APPLICATION NO.	FILING DATE	FIRST NAMED INVENTOR	ATTORNEY DOCKET NO.	CONFIRMATION NO.
09/986,956	11/13/2001	Manuel Barbosa	11017-0006	6385
22902	7590	07/19/2006	EXAMINER	
CLARK & BRODY 1090 VERMONT AVENUE, NW SUITE 250 WASHINGTON, DC 20005			NGUYEN, XUAN LAN T	
			ART UNIT	PAPER NUMBER
			3683

Office Action Summary

DETAILED ACTION

FIG. 1

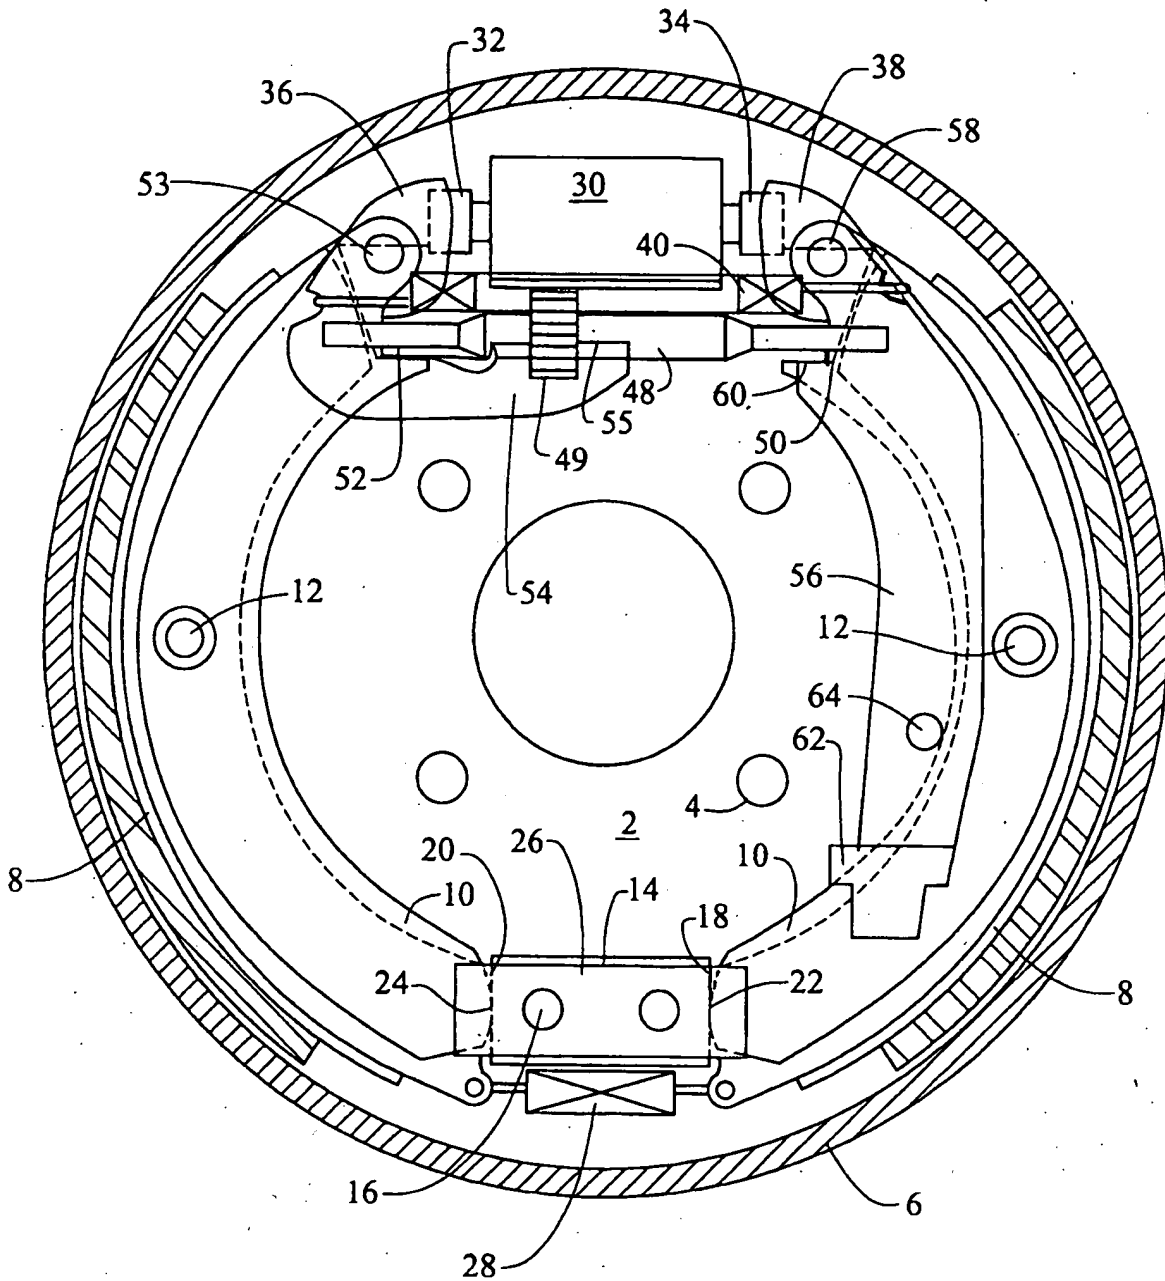
1. The drawings were received on 4/21/06. These drawings are approved.

approved
XLN
7/13/06
